City of Albuquerque

**Re: Ventana Ranch West Subdivision Drainage Management Plan, Addendum 1
Engineer's Stamp dated 12-24-03, (B8/D1)**

**ADDENDUM NO. 1
FOR THE
VENTANA RANCH WEST SUBDIVISION
DRAINAGE MANANAGEMENT PLAN**

FIGURE 2 BASIN MAP	S.F.G./R.M.G.	12.24.03
	S.M./B.T.D.	040140 001.CWH

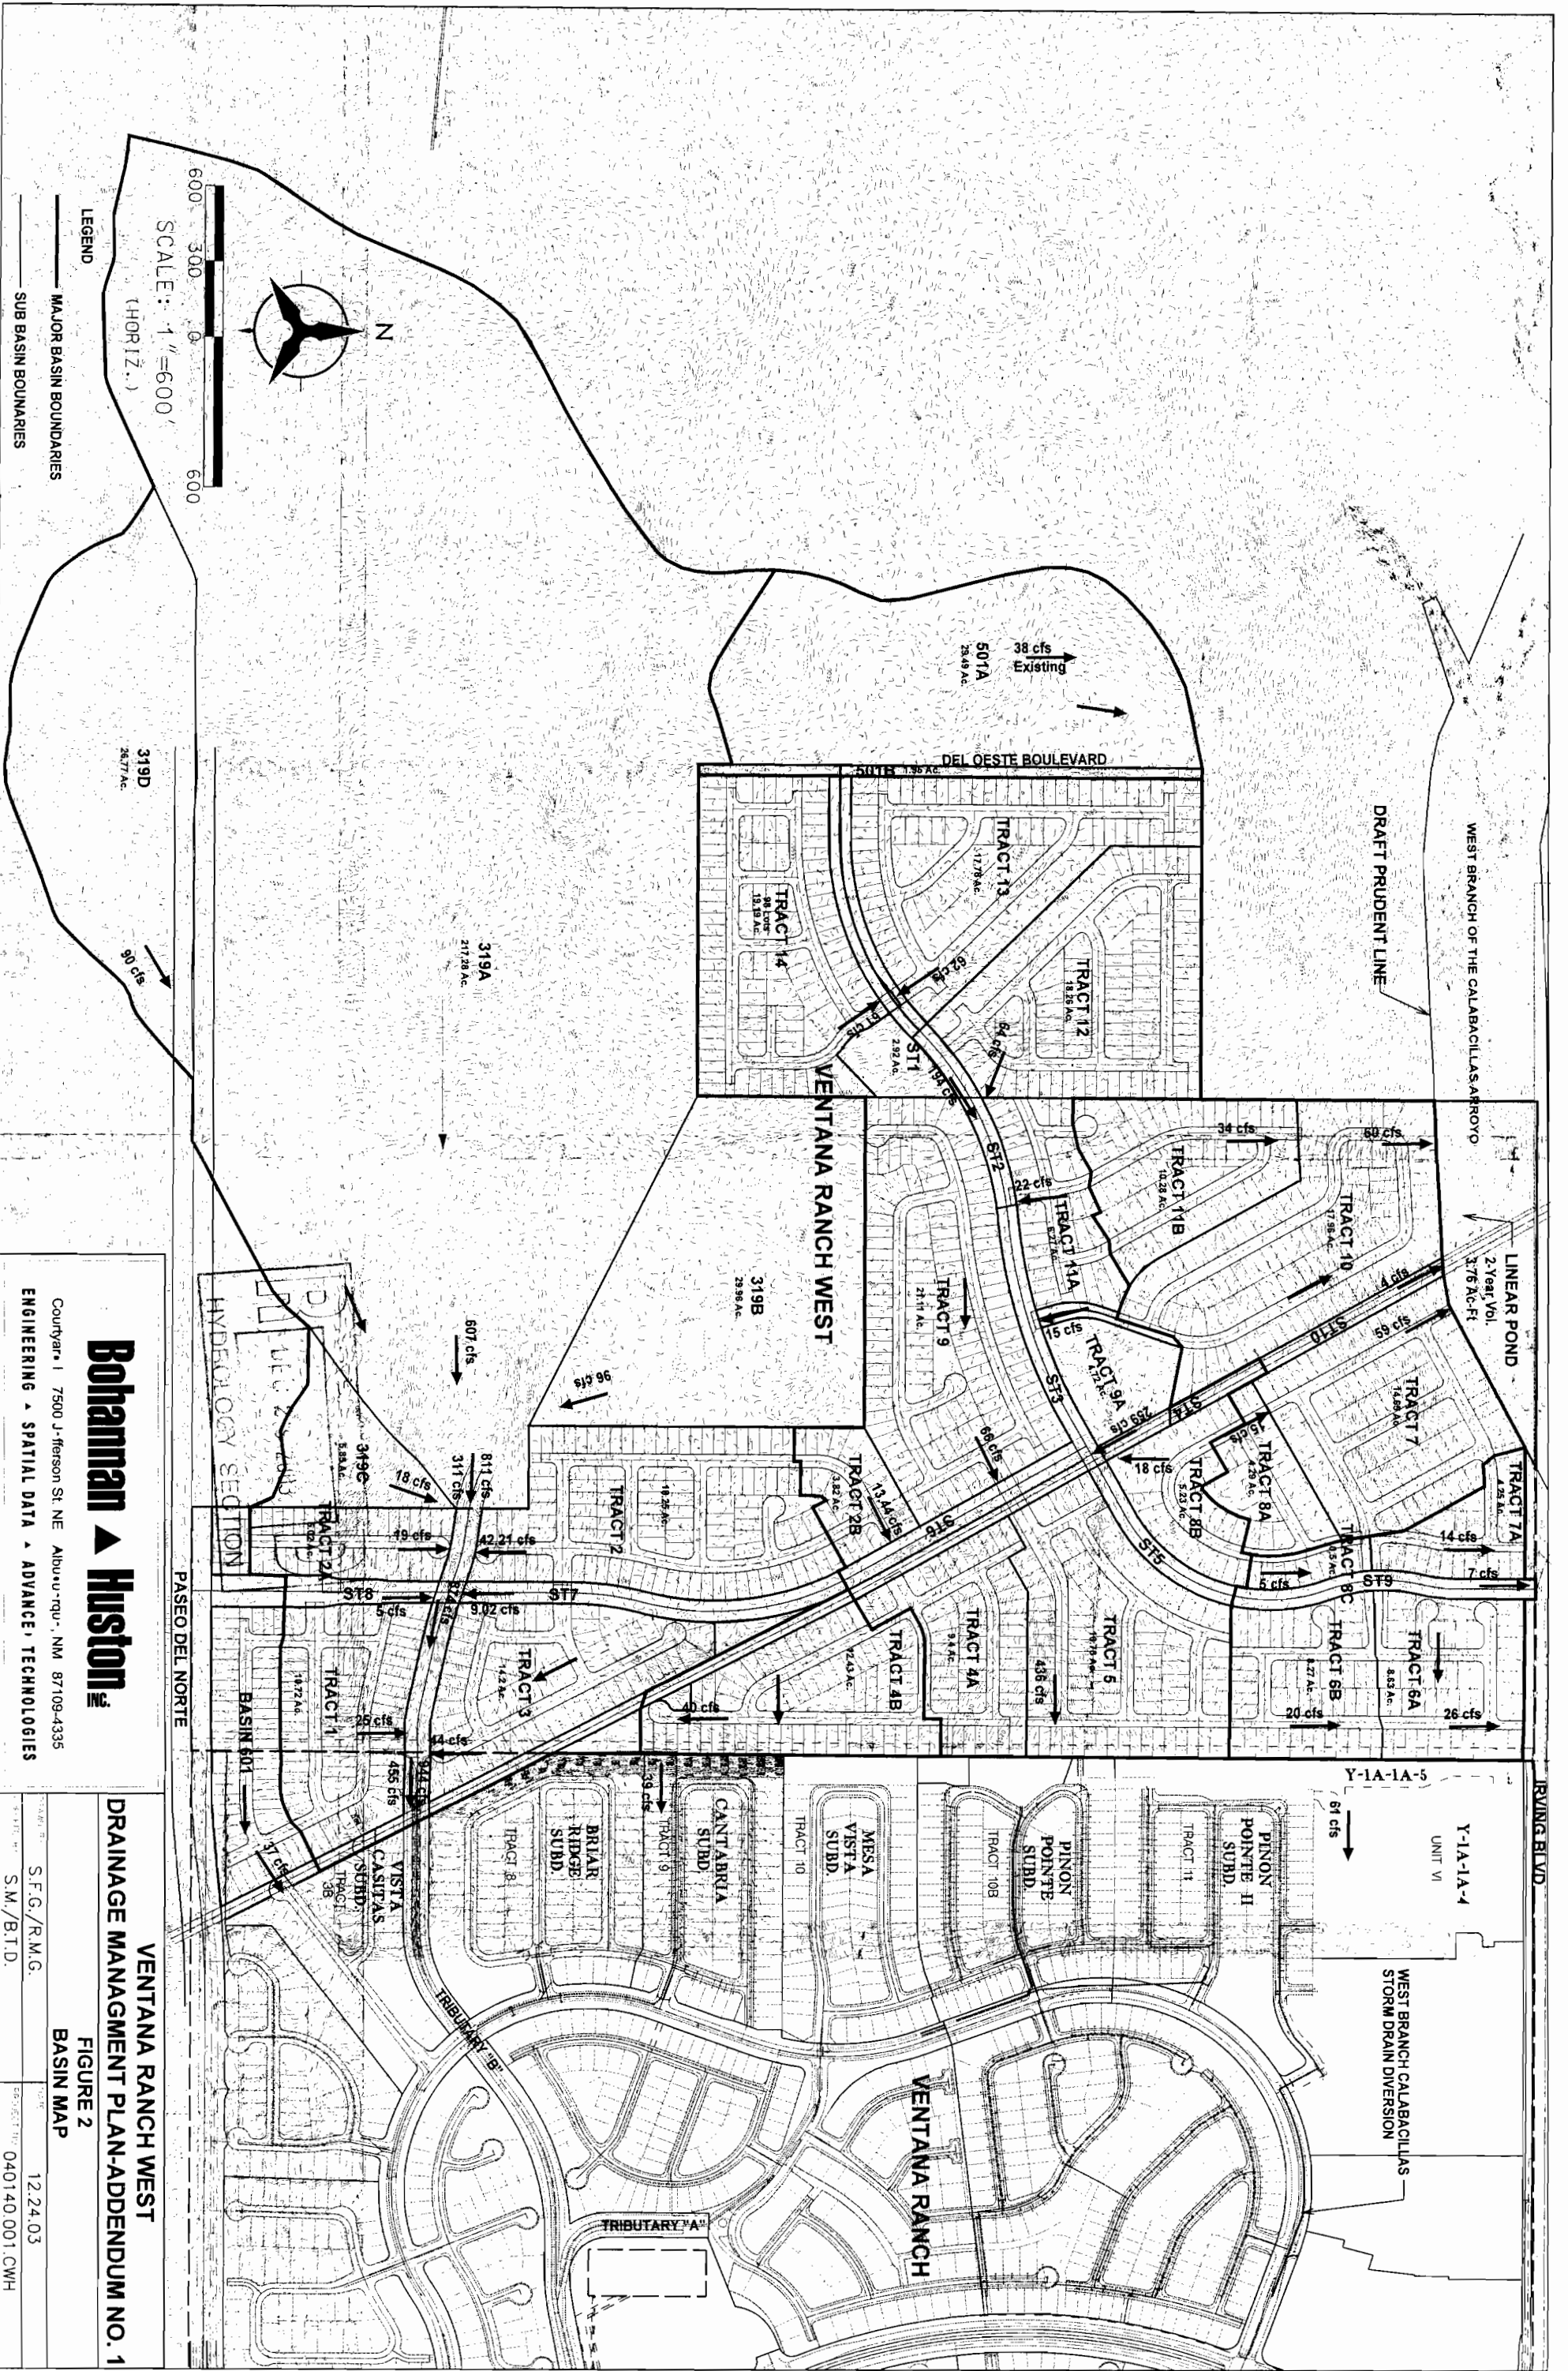
- Please address the area just west of Basin 601 and north of Paseo del Norte. This area must drain through your site as well.
- Please include any existing platting within the boundaries of your upstream basin and include any tract bisected by your developed-basin boundary line in its entirety. It is possible that the offsite runoff may increase.
- The design of your proposed pipe should be for the 944 cfs planned for at eastern edge of the Tracts 1 and 3, not 811 as shown.
